Request for Information No. II
RFP No. 22/23-01 IT Wide Area Network Project
September 8, 2022

Response to Proposers' Questions

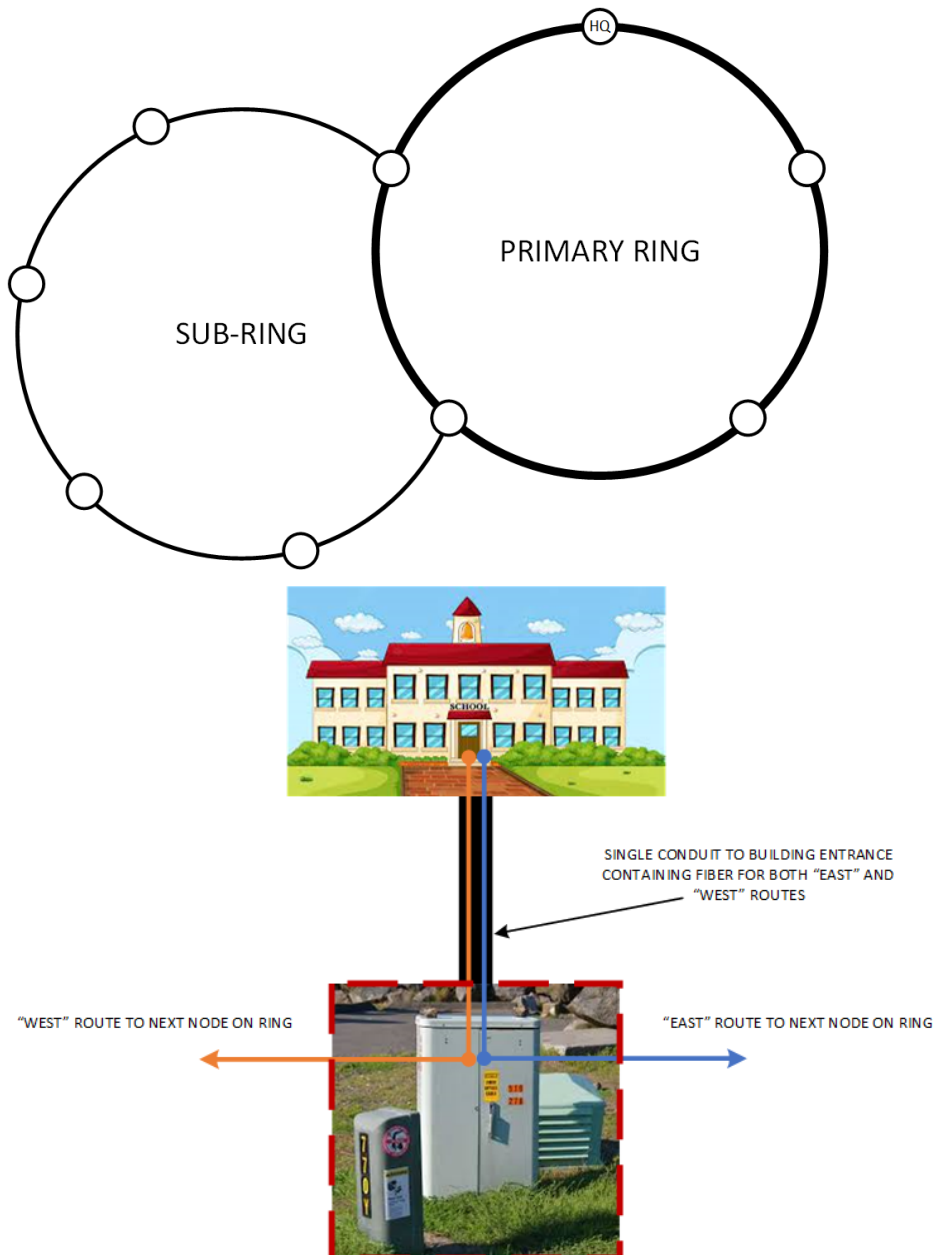
2.1 **Question:** Is there a Visio diagram for the project? Does it list how you want "sub rings" connected?

Answer: Following are conceptual drawing(s) of the desired network topology.
